ADDENDUM No. TWO

Project Name: Nature Center
White Clay Creek State Park

Contract No.: NAT25805-NATCTR
Date of Issue: Wednesday, May 20, 2026

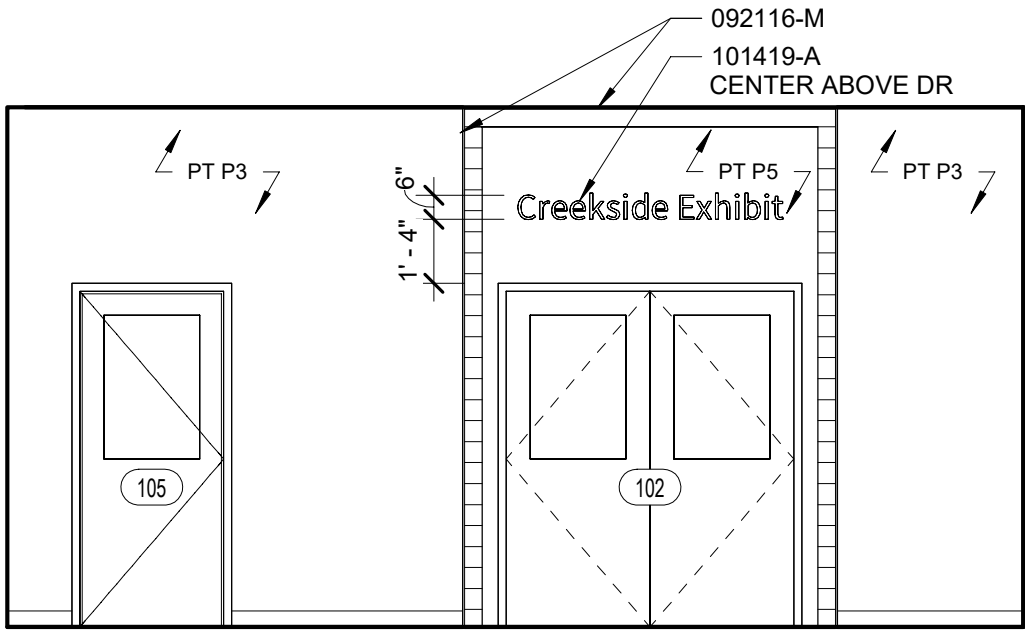
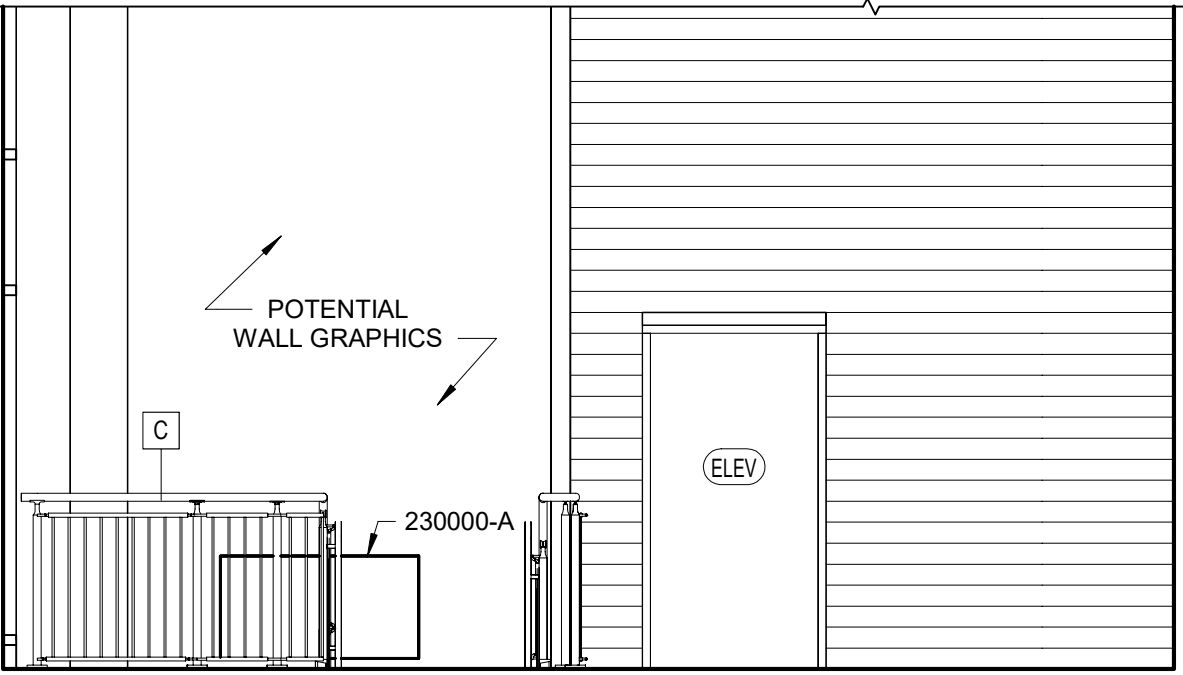
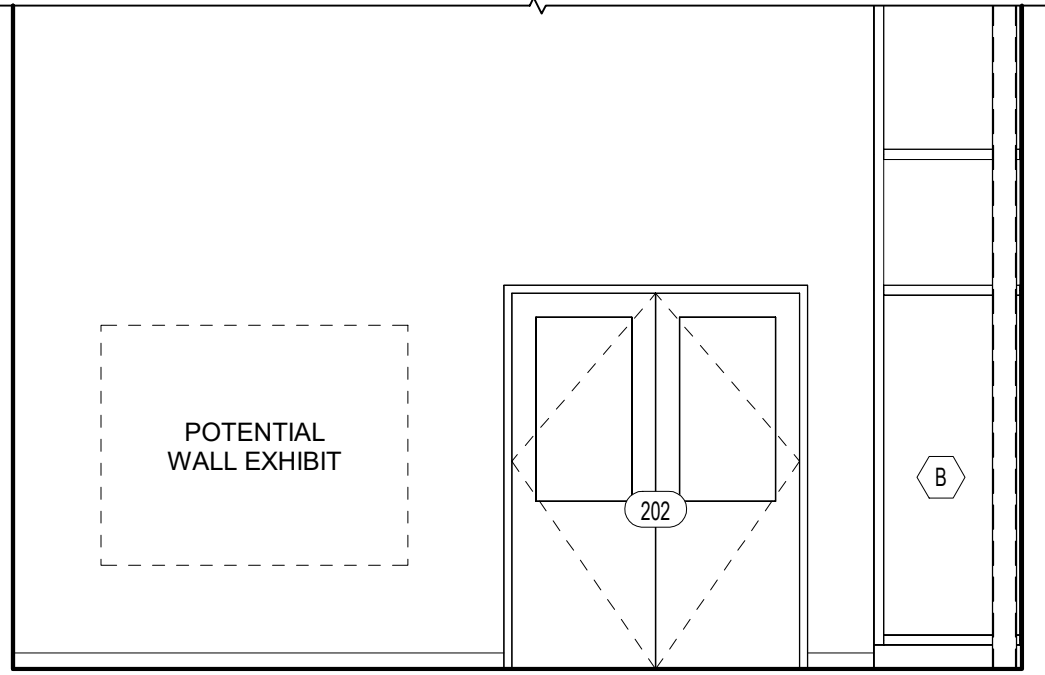
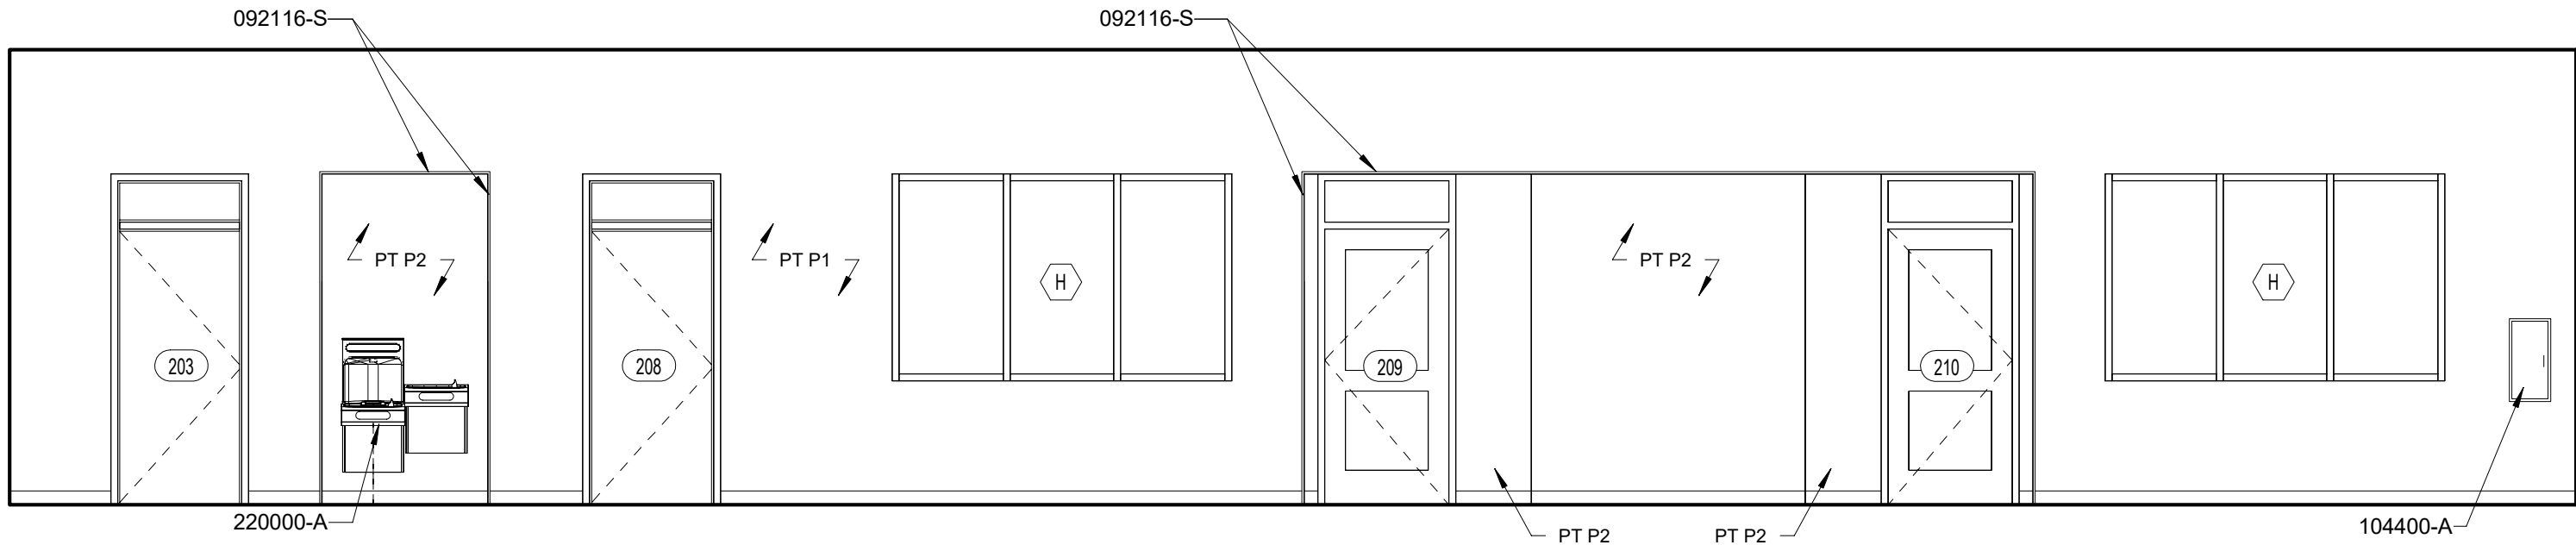
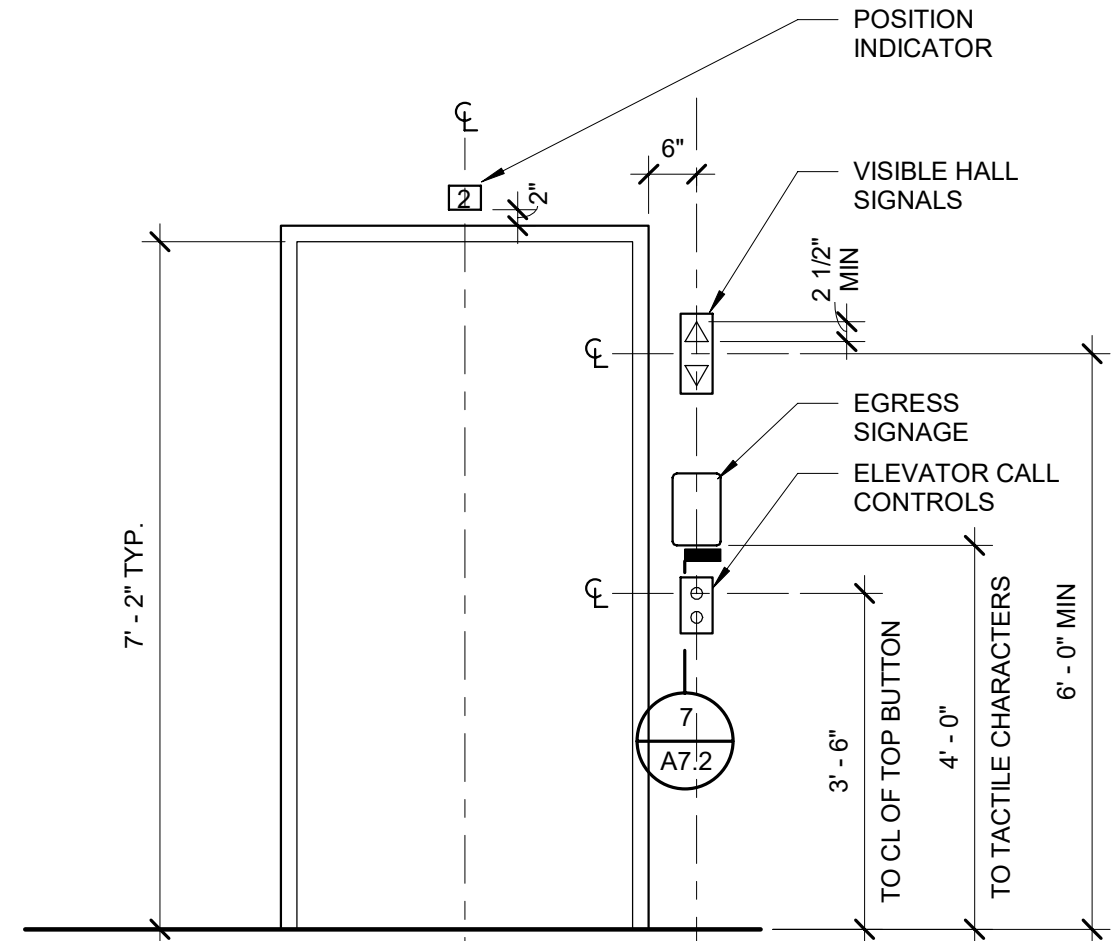
1. Sheet: A7.2 – INTERIOR ELEVATIONS
ADD: Keynote 064200-A to Legend.
ADD: TO BE PROVIDED BY OWNER to Reclaimed Wood Siding description.
2. Sheet: A9.1 – FINISH PLAN – LOWER LEVEL
REMOVE: Wall Finish W-1 from JANITOR CLOSET 109, RESTROOM 111, RESTROOM 112, RESTROOM 113, RESTROOM 114 on Finish Plan – Lower Level.
ADD: Wall Finish W-5 to JANITOR CLOSET 109 on Finish Plan – Lower Level.
ADD: Detail 4/A9.1.
REMOVE: SEE SPEC from Interior Finish Schedule Item W-4.
ADD: TO BE PROVIDED BY OWNER to Interior Finish Schedule Item W-4.

1 FINISH PLAN - LOWER FLOOR
A9.1 1/8" = 1'-0"

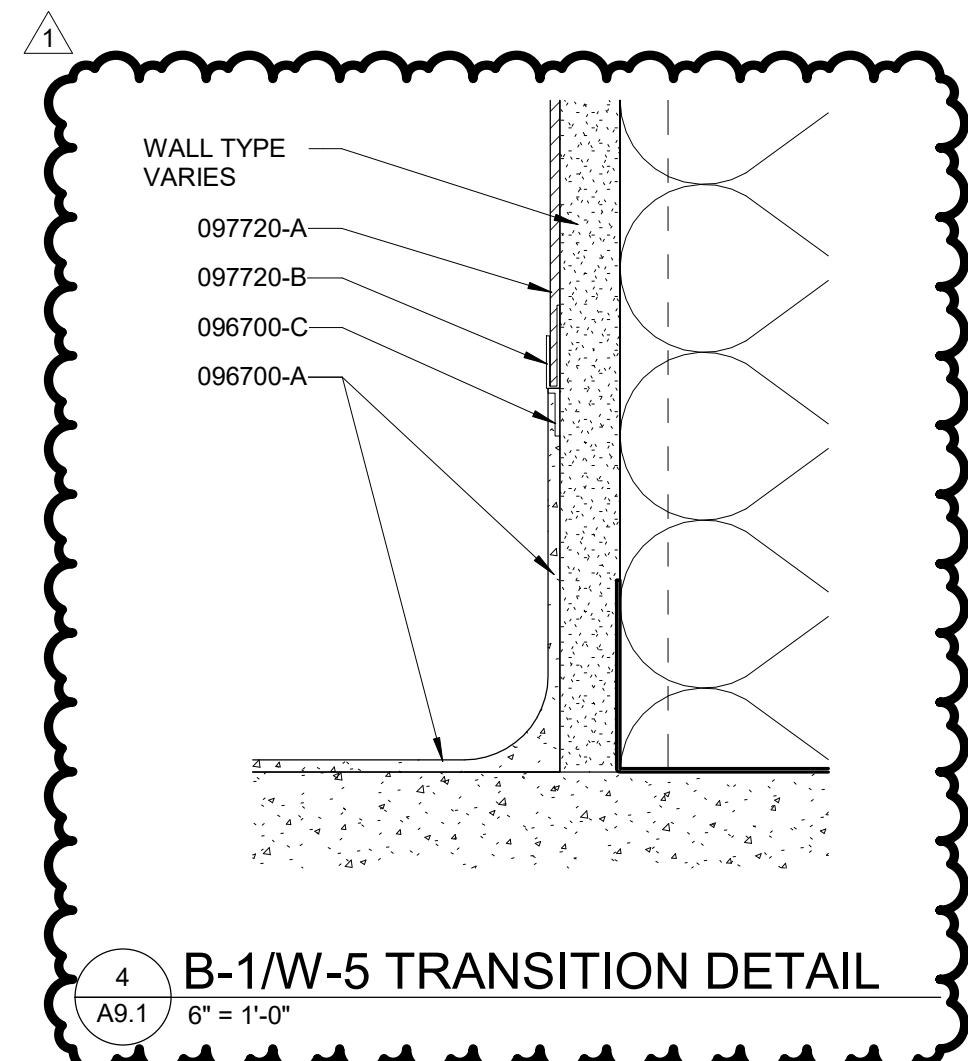
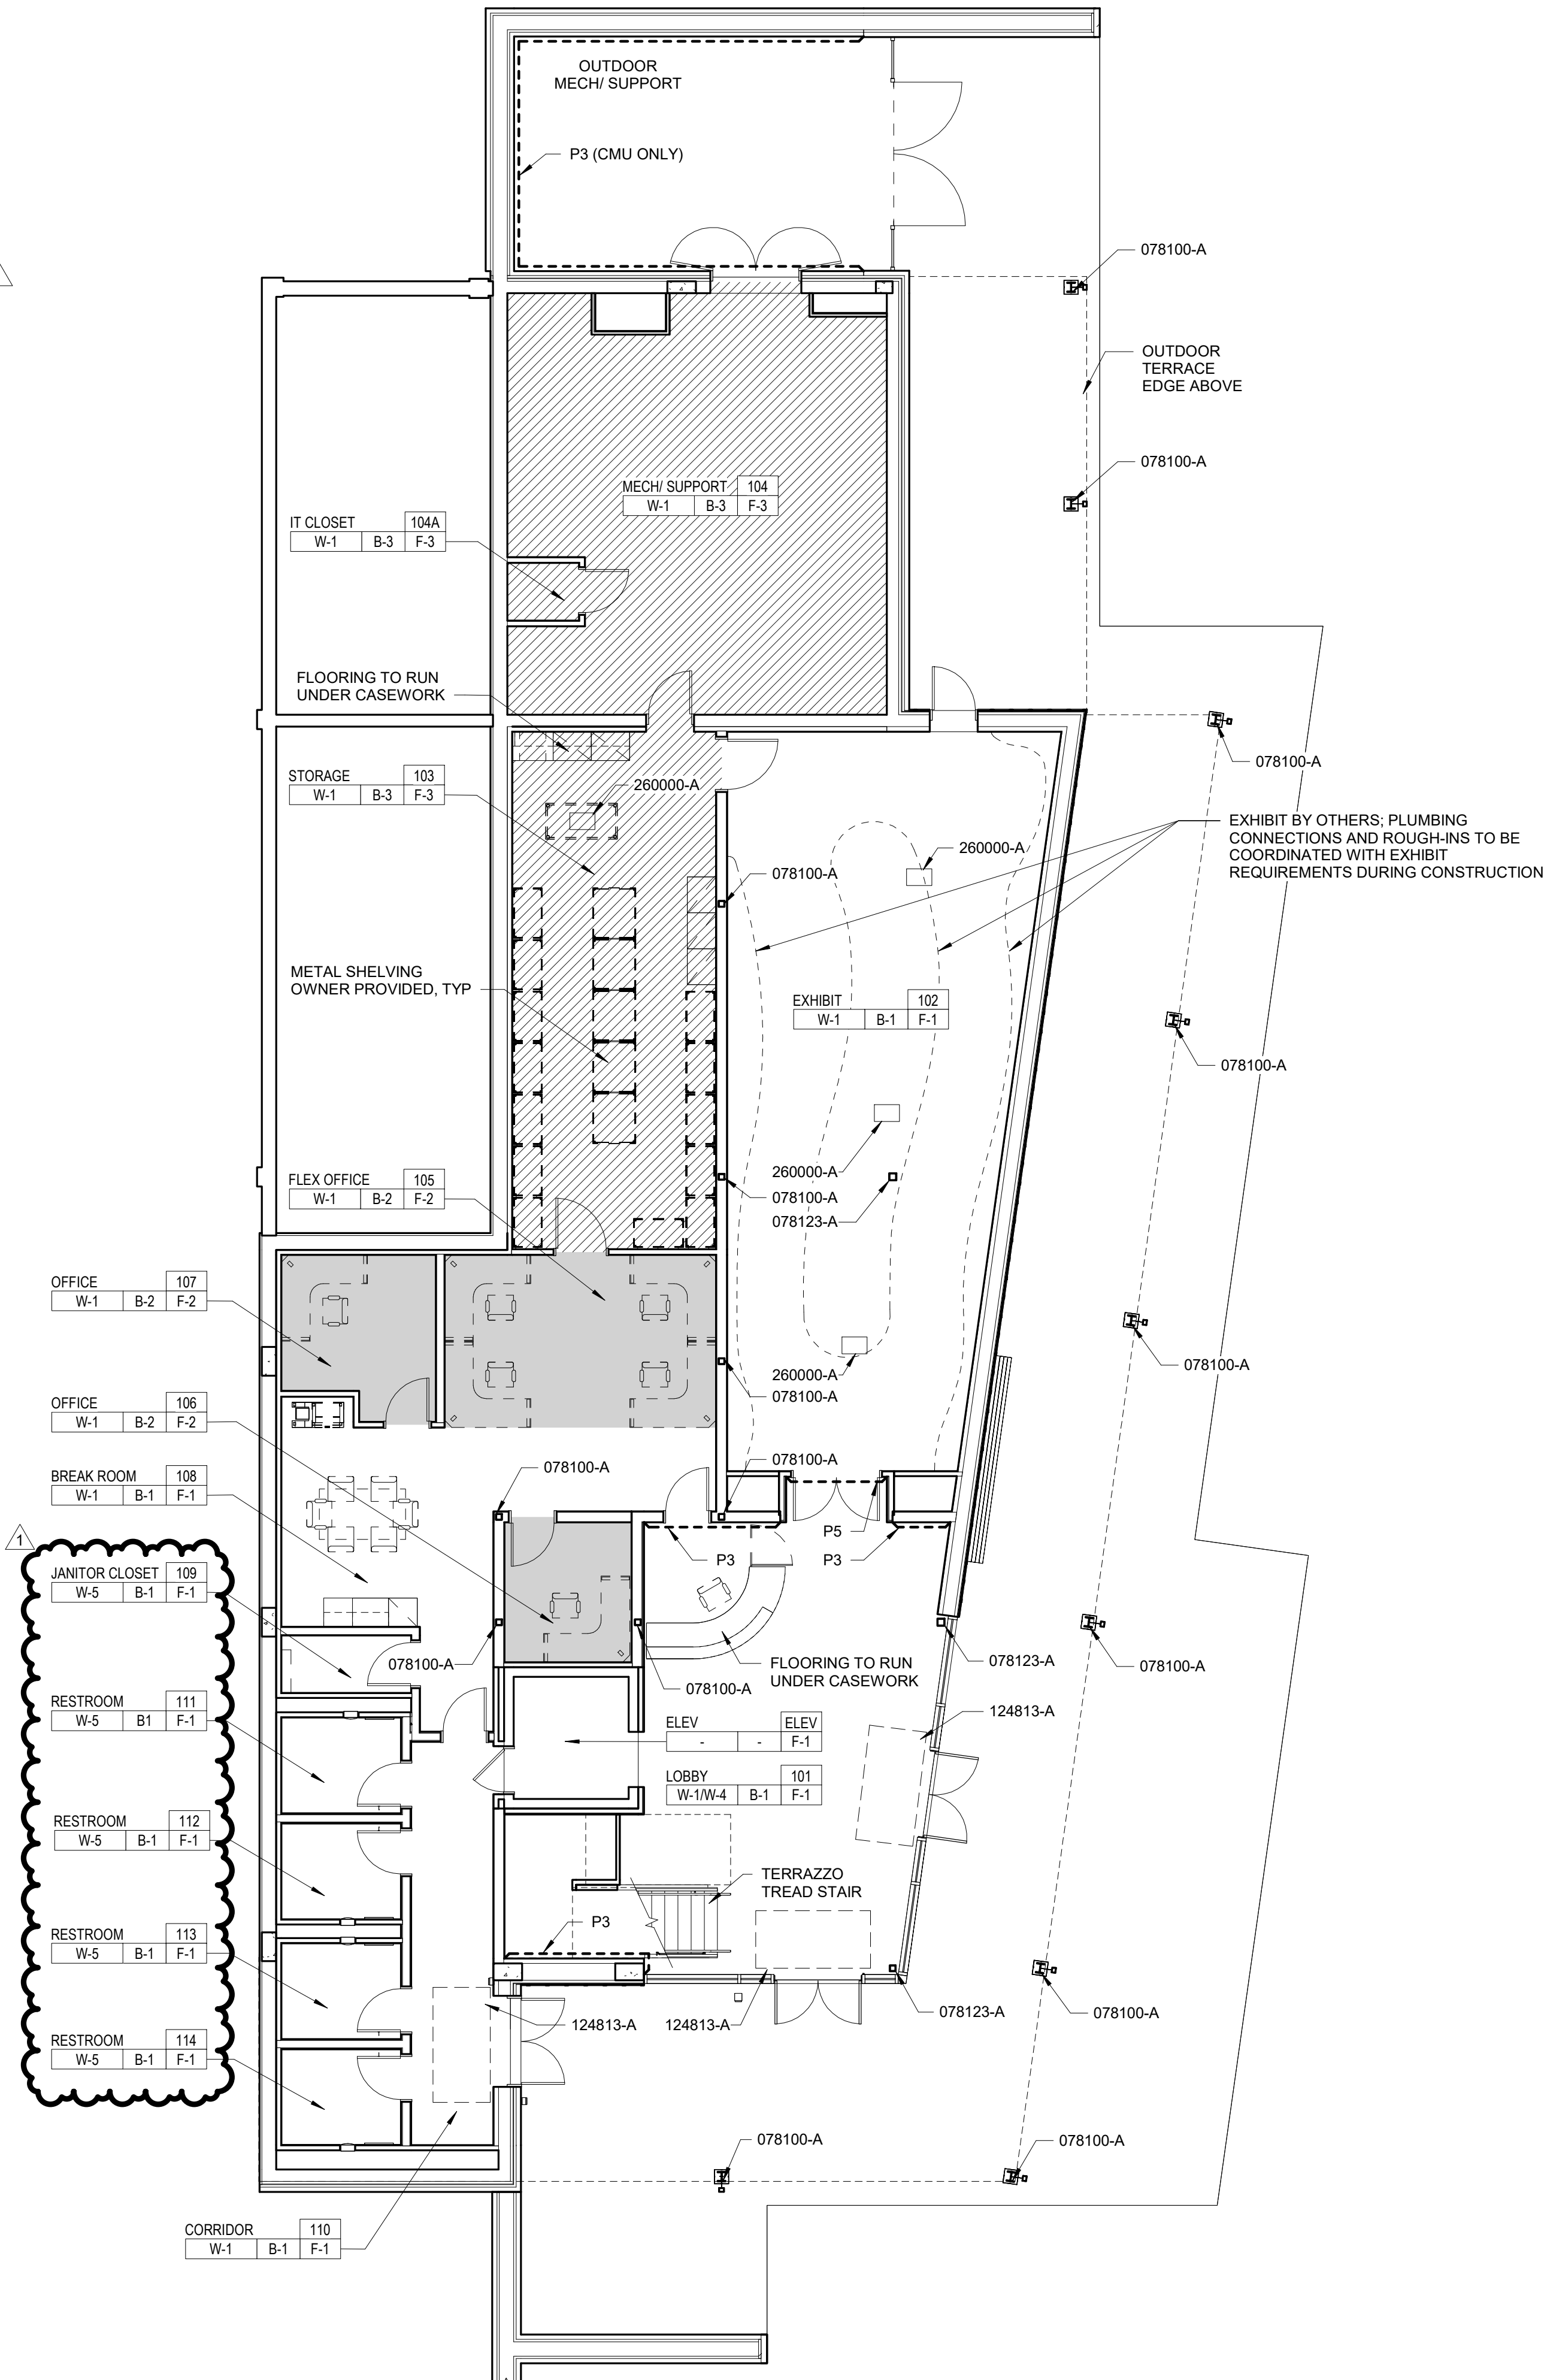
Response: Per specification section 12 48 13 Entrance Floor Mats, the mat will be placed over the epoxy flooring.
- 17 Question: (ARCHITECTURAL): Please provide FRP wall panel to epoxy base transition detail.

Response: The FRP panels should be installed from wall base to ceiling. Specification section 09 77 20 Fiberglass Reinforced Panels has been revised to clarify. Wall Finish W-1 has been removed from the Lower-Level restroom finish tags.

Response: Detail 4/A9.1 added.
- 18 Question: (ARCHITECTURAL): Are FRP panels w-5 noted on the finish schedule to be installed from base to ceiling or partial height only?
